## Summary of Items Discussed in 4/2023 APSEC Discussion Forum (ADF) on 17 November 2023

SECTION  
(Non - Domestic Building)

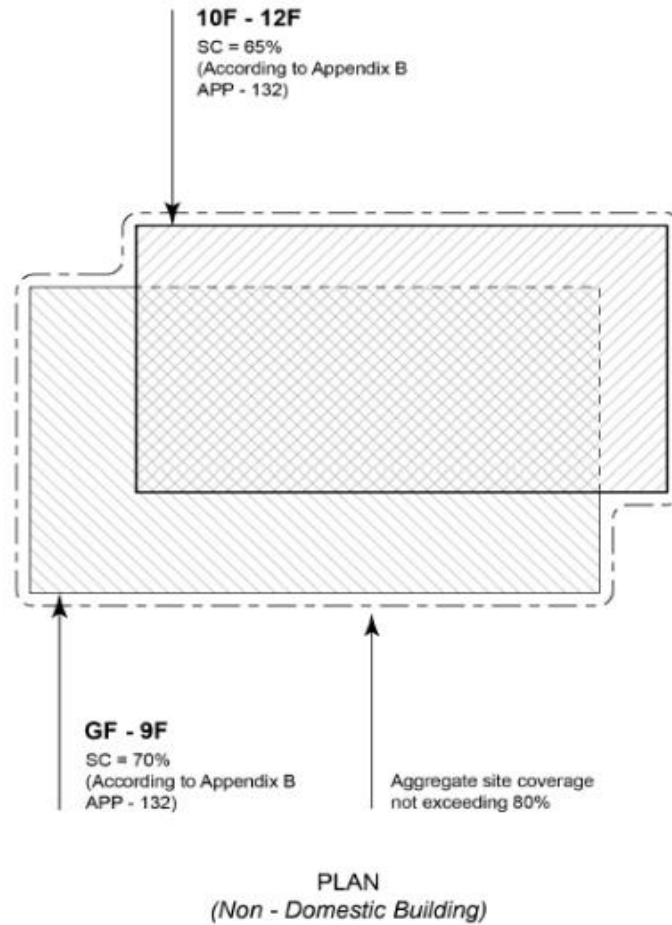
2.	<p><b><u>Site Coverage Flexibility under PNAP APP-132 – Minor Projecting Features</u></b></p> <p>As one of the criteria for considering the flexible application of the site coverage requirements under regulation 20 of the Building (Planning) Regulations (B(P)R) on the ground of setting back a building for its full height from a site boundary abutting on a street, it is stated in paragraph 3(d) of PNAP APP-132 that <i>“the setback area is properly landscaped and/or paved and open, <b>uncovered</b> and without any permanent building structures other than the landscaped features and perforated boundary walls.”</i></p>	<p>BD advised that according to footnote 3 of PNAP APP-132, the projections under PNAP APP-19 was excluded from the calculation of the total covered area of the buildings on the site for the purpose of determining whether an unexcavated or backfilled area and open-sided covered areas of green features described under paragraph 4 of the said PNAP could be excluded from site coverage assessment. According to paragraph 3(d) of PNAP APP-132, building setback area should not have</p>

<p>Following the principle for “total covered area” stated in footnote 3 of PNAP APP-132, we understand that “projections” under PNAP APP-19 are allowed within the setback area. Please confirm if such understanding is correct.</p>	<p>any permanent building structures other than the landscaped features and perforated boundary walls. In this regard, projections other than landscape features (i.e. metal supporting frames for growing of plants) under PNAP APP-19 were not allowed within the setback area.</p>
<p>3.</p>	<p><b><u>Site Coverage Flexibility under PNAP APP-132 – Aggregated Site Coverage</u></b></p> <p>For assessing the site coverage for buildings under PNAP APP-132 and to allow innovative building forms, would BD take a pragmatic approach to allow the permitted percentage site coverage listed in Appendices A and B to the said PNAP be applied discretely to each storey according to its corresponding building height stratum as illustrated in the diagrams below?</p>	<p>BD advised that in accordance with regulation 2 of the B(P)R, site coverage referred to the area of the site that was covered by the building that was erected thereon. For assessing the site coverage of the building at a particular level under PNAP APP-132, area at that level covered by the structure above should be included in the site coverage calculation. Hence, the aggregate site coverage of the non-domestic building at the levels of G/F to 9/F as illustrated in the diagrams should not exceed the permitted site coverage according to its corresponding levels set out in Appendix B to PNAP APP-132.</p>

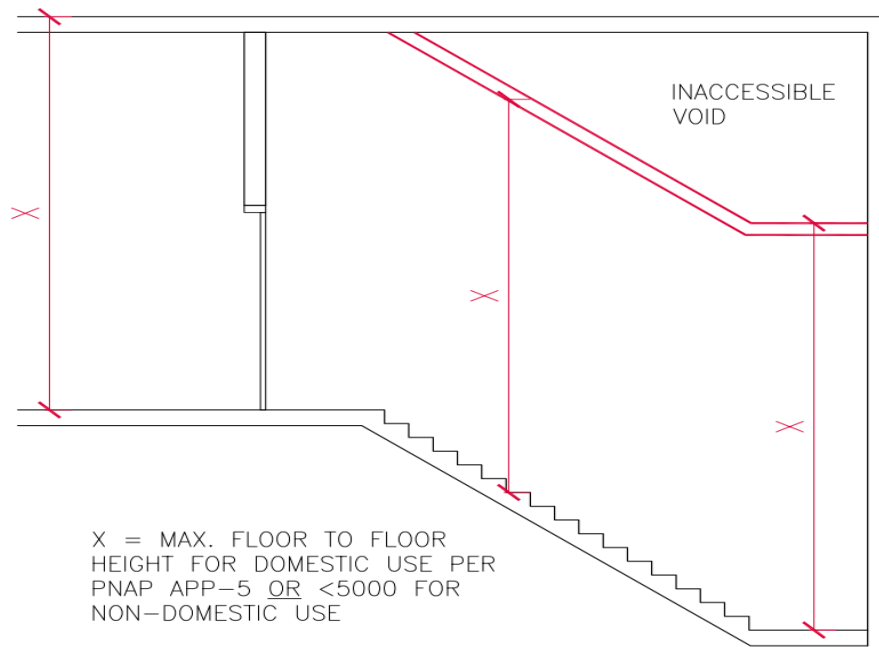
<p>8.</p>	<p><b><u>Maximum Headroom of Required Staircases for Common Use</u></b></p> <p>In some recent cases, APs are required to add a false slab above the area with</p>	<p>BD advised that the HKIA’s understanding was correct.</p>

headroom higher than the maximum storey height allowed in paragraph 5 of PNAP APP-5 in the required staircases for common use in domestic buildings, which is normally found at their uppermost flight, so that the headroom would not exceed the maximum storey height allowed in the said PNAP. It is considered that the concerned area is a common area of the building and the chance of abuse of use is highly unlikely, if not impossible. It is our understanding that such false slab is therefore not required. Would BD please clarify whether our understanding is correct or not?

9. **Partial Screening of External Drainage Pipes by Architectural Features – Appendix C to PNAP APP-93**

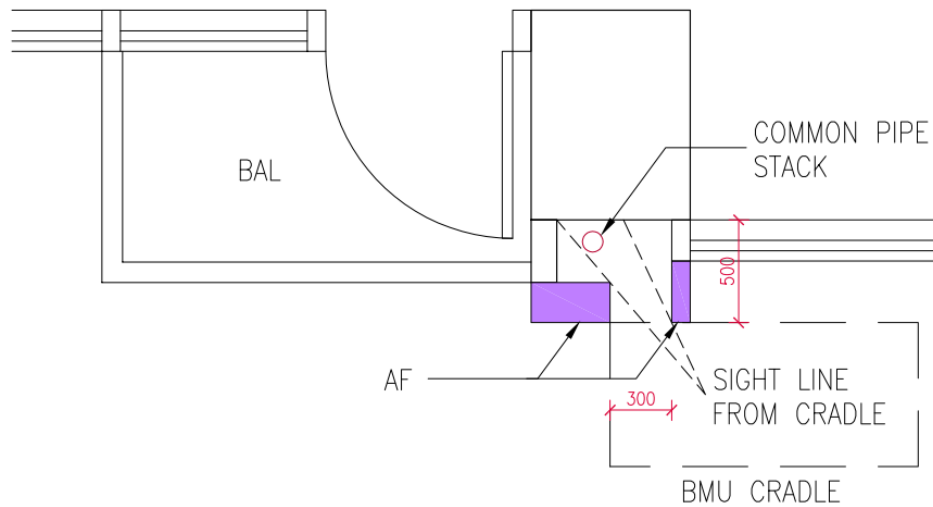
In accordance with Appendix C to PNAP APP-93, the pipes should be exposed to the external at least on one side. As illustrated in the sketch below, direct visual sightline for pipes can be achieved via a building maintenance unit (BMU) with a reachable distance for maintenance. Would BD consider that such arrangement fulfils the requirements in Appendix C to the said PNAP.

BD advised that the proposed arrangement illustrated in the sketch was not acceptable as the pipe could not be readily inspected without the use of BMU, and hence did not fulfill the requirement in Appendix C to PNAP APP-93. Also, pursuant to paragraph 1.2 in Part 3 of the Code of Practice on Access for External Maintenance 2021, the maintenance and repair (M&R) should enable the workers to reach the extended external building elements within a hand-reachable range of not more than 500 mm. It appeared that architectural feature in the sketch would hinder carrying out the M&R works.

SK-01

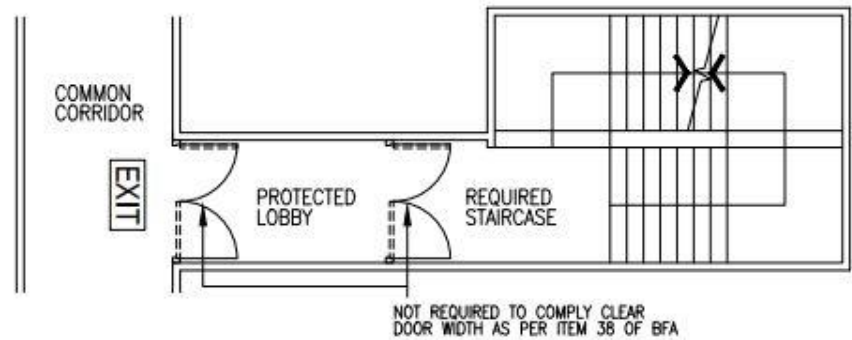
It is our understanding that the required staircase and its protected lobby are not “accessible route”, and therefore the related doors do not have to meet the requirement stated in paragraph 38 in Division 10 of DMBFA, as shown in the diagram SK01 below. The exception is that if TRS is located in the subject protected lobby, doors leading to TRS should meet the said requirement, as shown in the diagram SK02 below. Would BD please advise if our understanding is correct or not?

BD also drew members’ attention to Clause B30.3 of the FS Code which required the minimum clear width of door leading to a TRS to be 850 mm. Item 15 of ADF 3/2016 held on 27 May 2016 was relevant.

12. **Measurement of the Width of Exit Door**

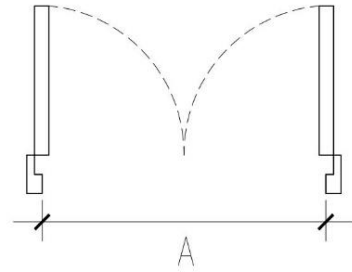
Notes 2 of Table B2 of the FS Code states that *“the width of an exit door should be the least clear width measured between the vertical members of the door frame.”* Our understanding is that the measurement should be taken according to the diagram below. Would BD please advise if our understanding is correct or not?

BD advised that HKIA’s understanding was correct.

Scenario 2 – Semi-sunken car park not considered as underground car park under paragraph 3 of Appendix C to PNAP APP-2 (i.e. considered as

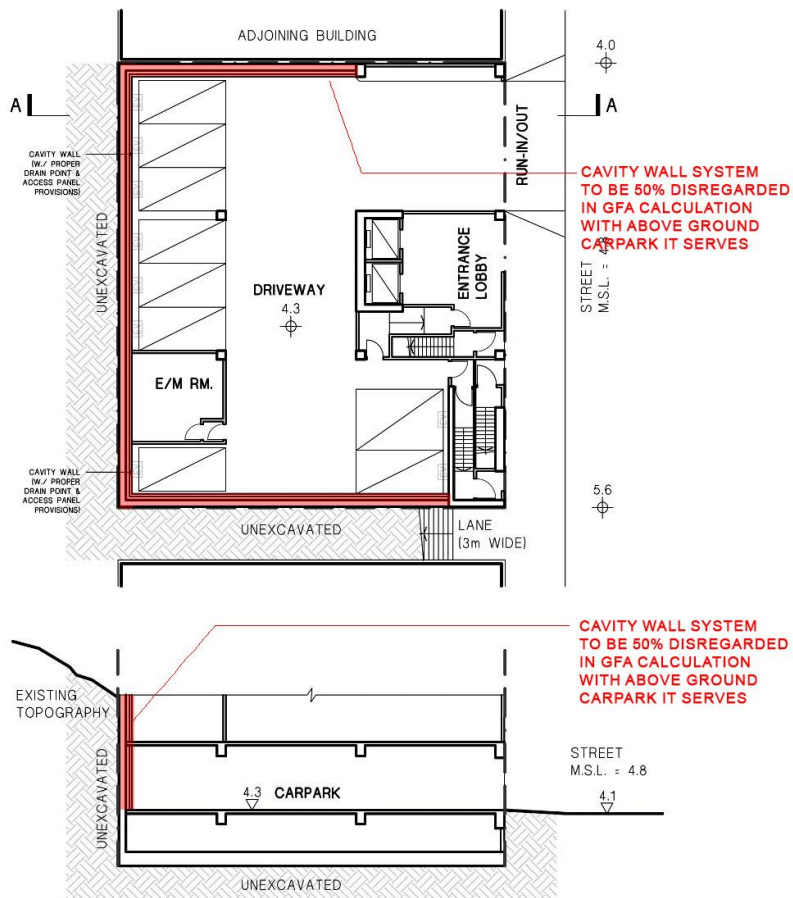
The private car park is considered aboveground under the prescribed requirements in PNAP APP-2. 50% of the floor area of the cavity wall system ancillary to car park shall be disregarded together with that of the car park floor it serves.

<p>Please confirm if our understanding is correct.</p>	
<p>16.</p>	<p><b><u>Access to a Fireman’s Lift at Ground Storey – Clause D7.3 of the FS Code</u></b></p> <p>As discussed in item 8 of ADF 2/2023 held on 5 May 2023, the communication between the remainder of the ground floor with occupancy and passage from the fire service access point (FSAP) to the fireman’s lift at ground floor cannot form an exit route for such occupancy use.</p> <p>We would like to seek BD’s clarification on whether the exit route for such occupancy use can go through the passage leading from the FSAP to the fireman’s lift at ground floor but not discharging through the FSAP, as shown in the diagram below:</p>	<p>BD advised that according to item 8 of ADF 2/2023 held on 5 May 2023, the arrangement shown in the diagram was not acceptable as the opening serving as the exit of the function room which possessed occupant capacity, instead of serving for communication purpose only.</p>

17. **Access to a Fireman's Lift at Ground Storey – Clause D7.3 of the FS Code**

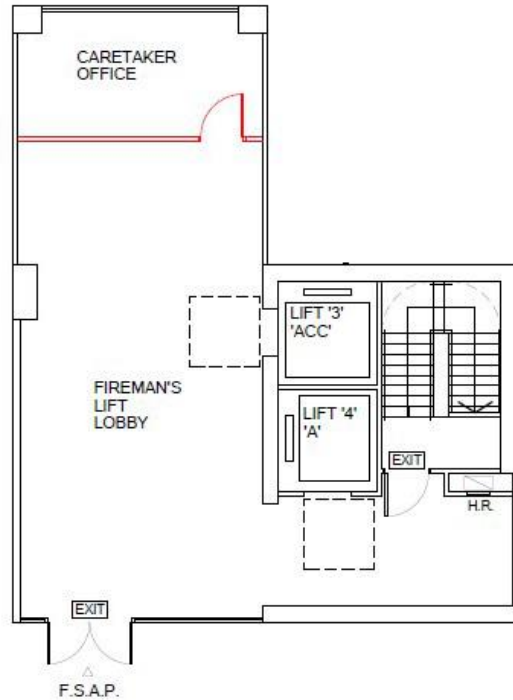
Clause B9.1 of the FS Code stipulates that *“the enclosing walls of every required staircase should be so continued at ground storey as to separate from the remainder of the building any passage or corridor leading from the*

<p><i>required staircase to its ground storey discharge point. Every opening from the ground storey to such passage or corridor should be separated from it by a protected lobby; provided that in the case of a building severed by two or more required staircases, <u>a cloakroom, lavatory, water-closet, caretaker's office, fire control room or caretaker's counter</u> may open off such passageway”.</i></p> <p>We would like to seek BD’s clarification on the following:</p> <ol style="list-style-type: none"><li>1) Whether fire barrier and protected lobby are required for opening in the wall between the abovementioned underlined uses and the exit route of the required staircase, which also serves as an access to a fireman’s lift at ground floor.</li><li>2) Whether the exit route for abovementioned caretaker’s office with occupancy could be discharged through the FSAP at ground floor.</li></ol> <p>Example layout diagram as follow:</p>	<p>did not fulfil the requirement for opening to the passage from the FSAP to the fireman’s lift in Clause D7.3 of the same code. BD would seek comments from the Fire Services Department on such arrangement of means of access.</p>

BD advised that the arrangement depicted in the diagram generally fulfilled the separation requirement within the enclosing walls of the required staircases at ground storey in Clause B9.1 of the FS Code, but
